FULL WRITTEN REPRESENTATION ON BEHALF OF SPIRIT ENERGY NORTH SEA LIMITED, SPIRIT ENERGY RESOURCES LIMITED AND SPIRIT ENERGY NEDERLAND B.V.

Figure 1: Oil & Gas Licences, Fields and Infrastructure (OGA 2018) Annotated to show Spirit Licences in Close Proximity to Hornsea Project Three

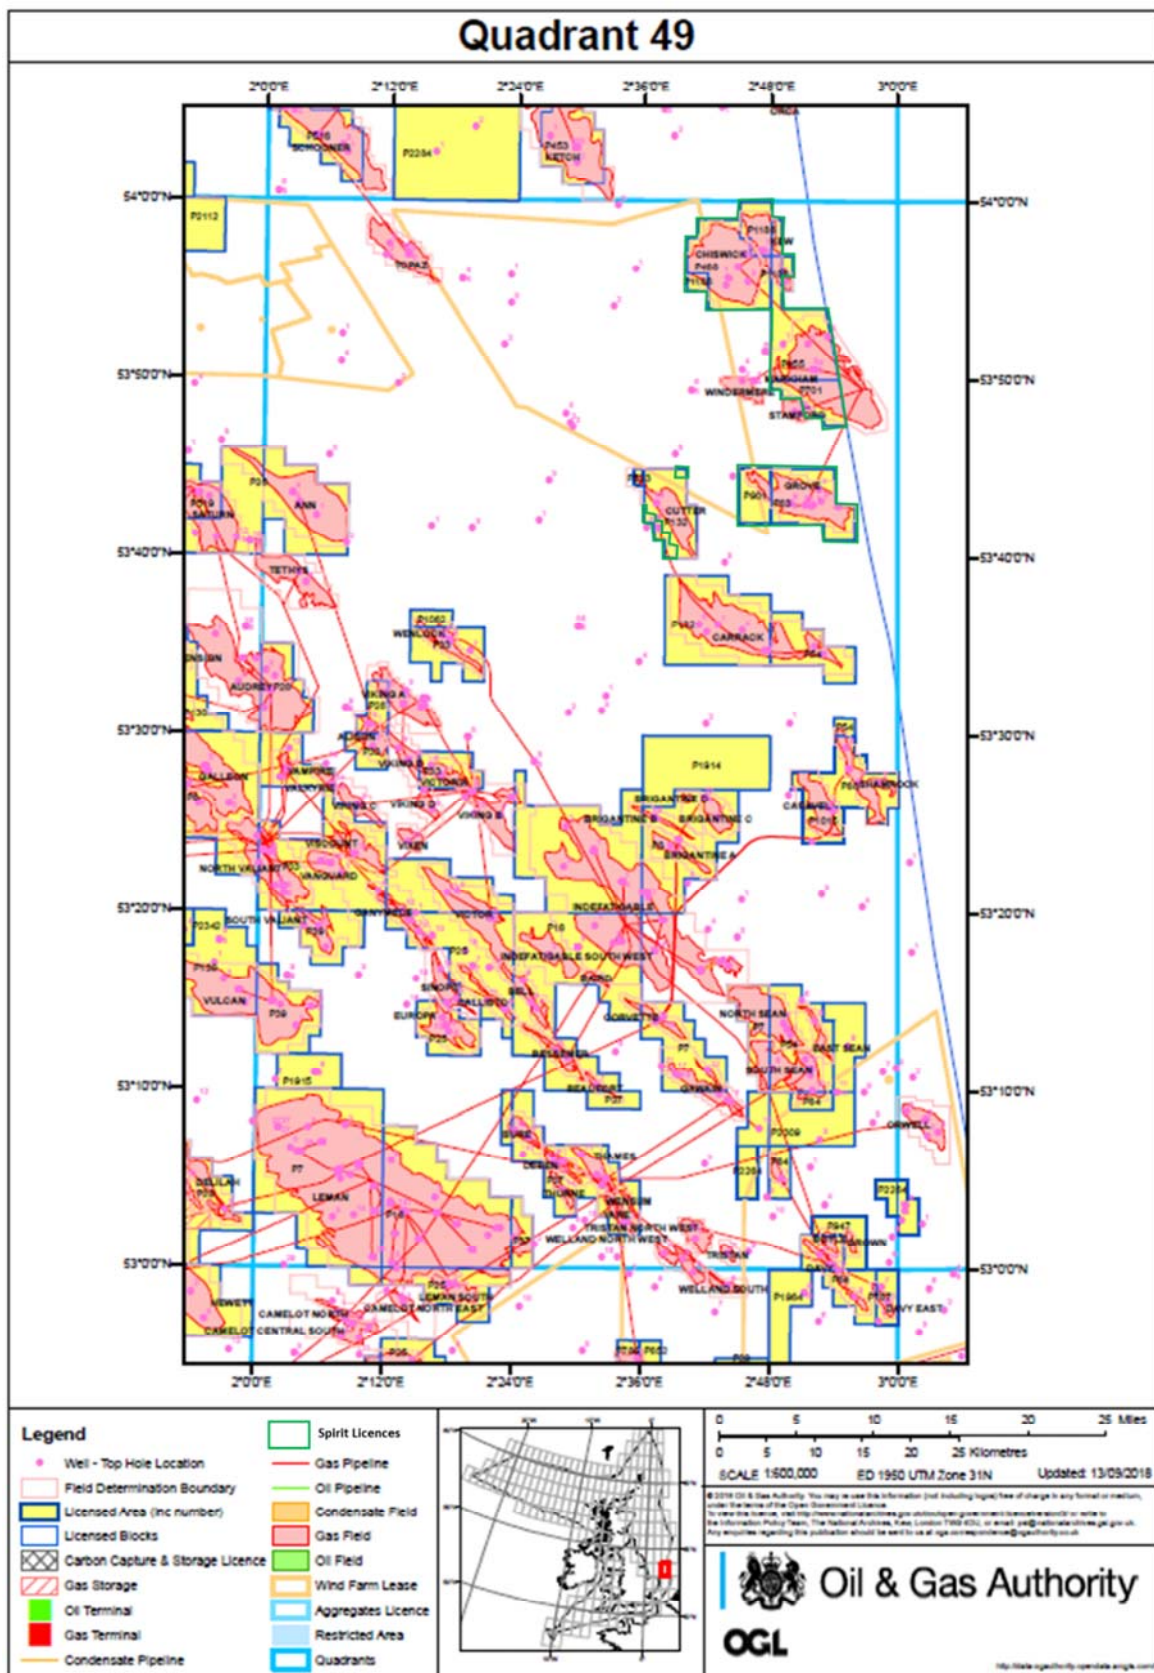
- 2.1 The Project will impact Spirit's interests in the Greater Markham area (See Figure 1), which comprise a group of producing fields straddling the UK/Dutch border exporting gas to the Netherlands. The producing fields are economically important to Spirit and its partners, to the UK Government and to the Dutch Government. Combined, the Greater Markham Area fields produced 23 billion cubic feet of gas net to Spirit in 2017.
- 2.2 A description of the key physical assets and infrastructure ("the Affected Assets") is as follows:

Figure 1: Planned Future Well Locations in Licence P.

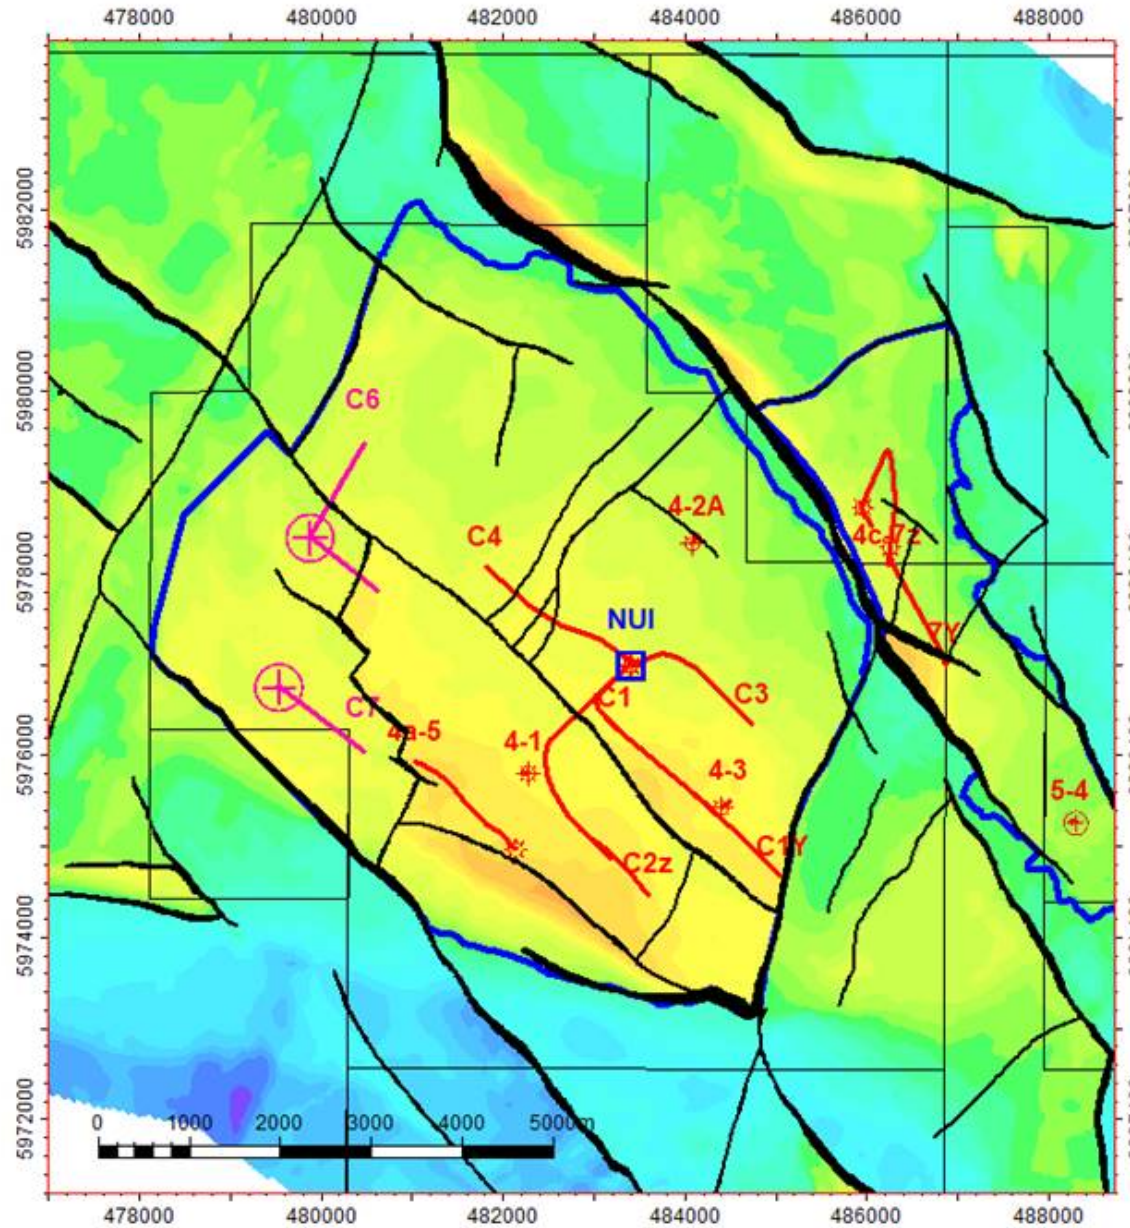
The Chiswick Field extends into the Development Site as do the associated licences P.468 and P.1186. Spirit Energy North Sea Limited has well developed plans to drill two further wells from subsea locations each within the part of the Chiswick Field lying within the Development Site. Due to technical issues it would not be viable to drill these wells from the Chiswick platform and for each of these wells a drilling rig would need to be located (at separate locations) within the Development Site each approximately 2nm or 3.7km to the west of the Chiswick platform. (The currently proposed drilling locations are shown by the two crosses within circles in Figure 1.)

Figure 2: Comparison of distances between wind farms and assets that Spirit operates or maintains

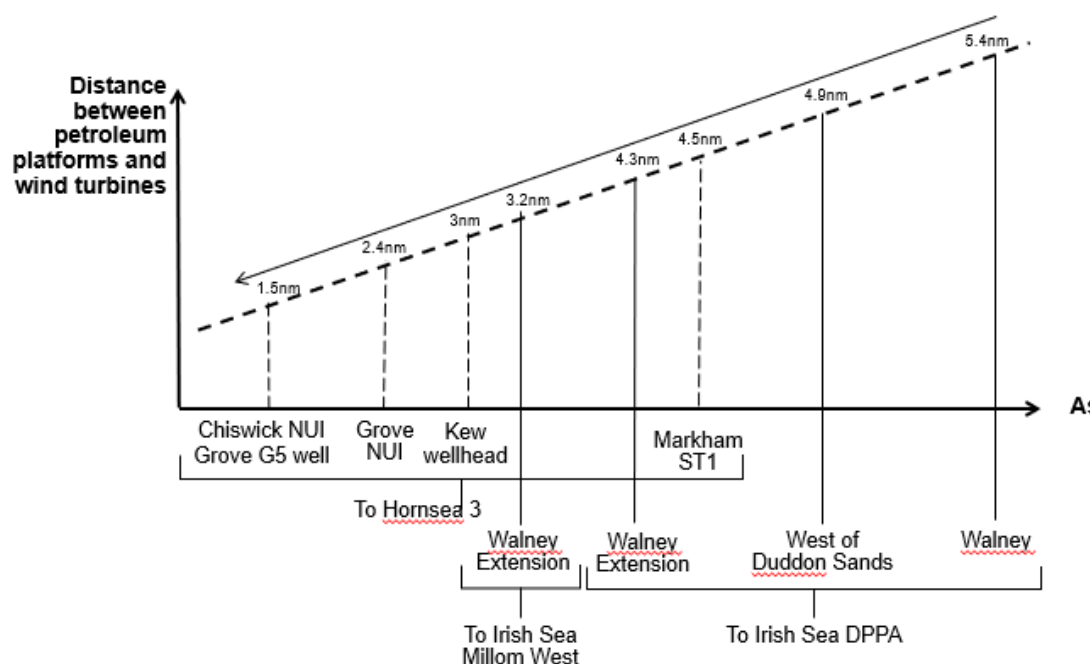
- 4.6.2 For the Project, Spirit's closest asset (the Chiswick platform) would be located 1.5nm or 2.8km from the turbine array.
- 4.6.3 The total height of turbines installed at Walney Extension are 165m whereas the proposed turbines for the Project may be 325m.

4.6.5 Figure 3 shows a graphical comparison of the distances between wind farms and assets in the East Irish Sea and the Hornsea area.
